A STUDY IN TEAK

DOORS — MADE IN VENEER

Same design · Planted mouldings · Construction only

SCALE	DATE
AS NOTED @ A3	**23.09.2026**
REV	DWG
2 — the design unchanged; only the construction differs	**AST-DR-015**

1 · THROUGH THE LEAF

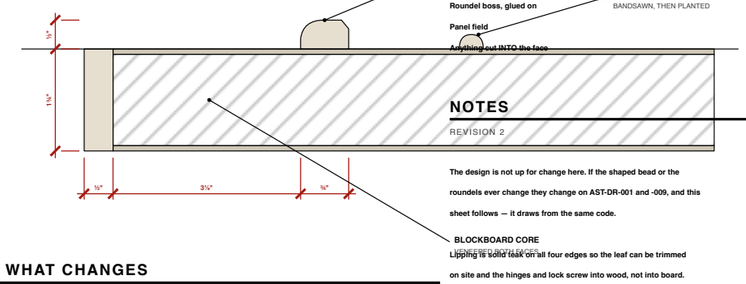
Panel field

was: sunk ½" into the solid

now: stays FLAT — the ovolo round it does the work

Ovolo sticking

was: worked on the stile edge

now: run as a separate ¾" × ½" moulding, mitred on

Shaped bead

was: carved into the panel face

now: bandsawn to the curve in ¼" × ¼", planted on

Corner roundels

was: carved bosses

now: turned discs Ø1" × ¼", glued on

The leaf

was: solid teak, 1¾"

now: 1⅛" blockboard, ½" lipping, veneer both sides

1 · THROUGH THE LEAF

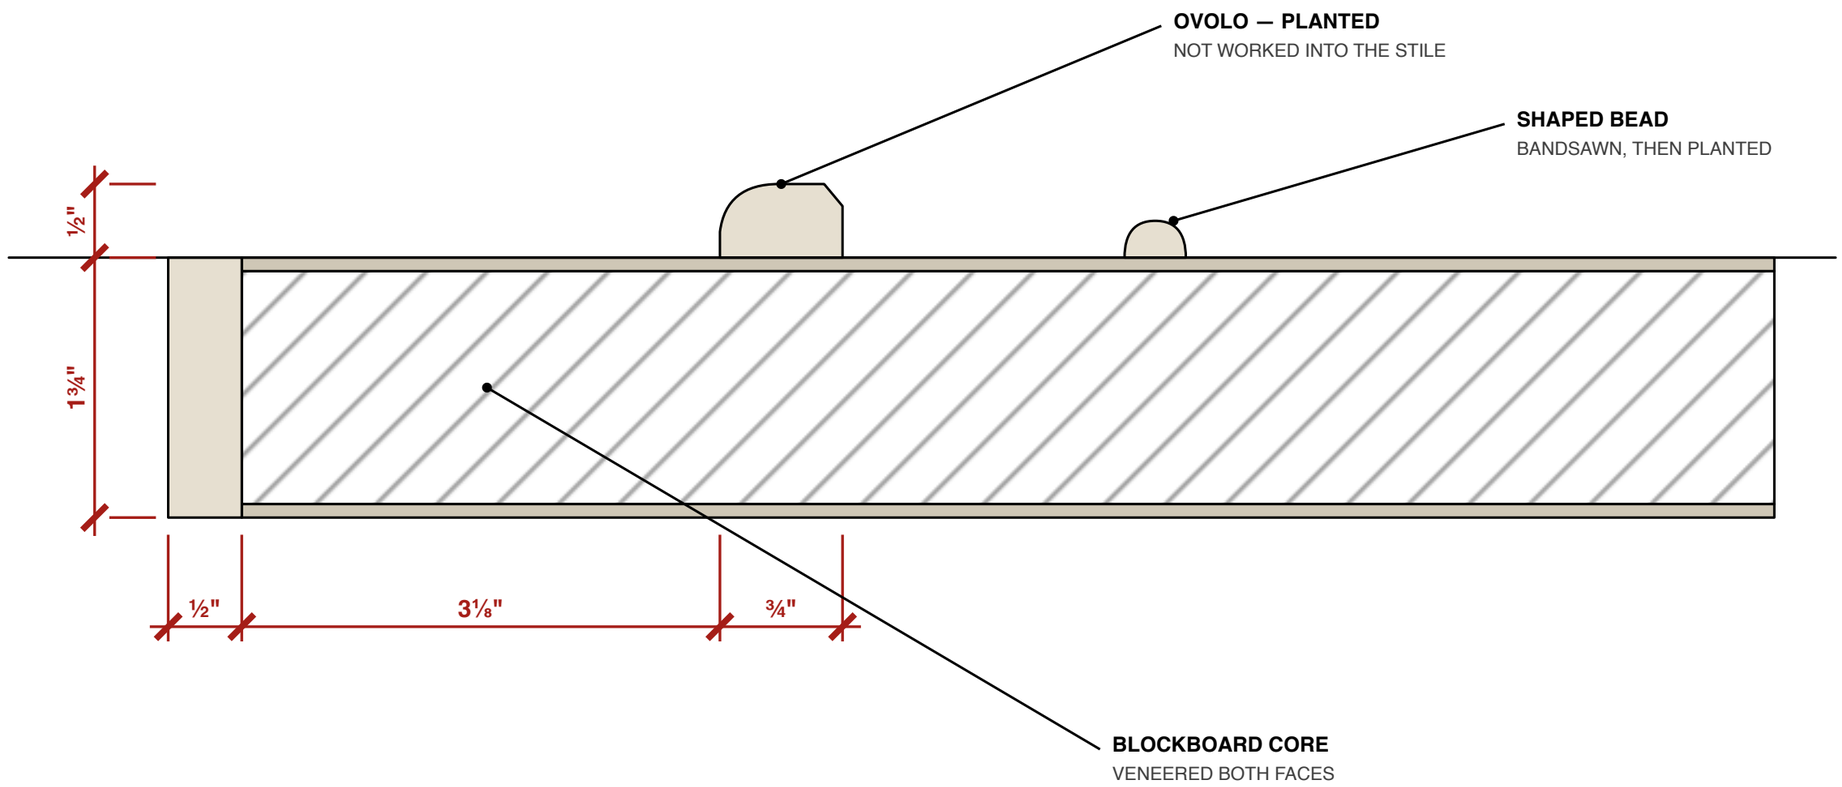
SCALE 1:1 (FULL SIZE) @ A3 · SECTION ACROSS A PANEL · EVERY MEMBER PLANTED ON
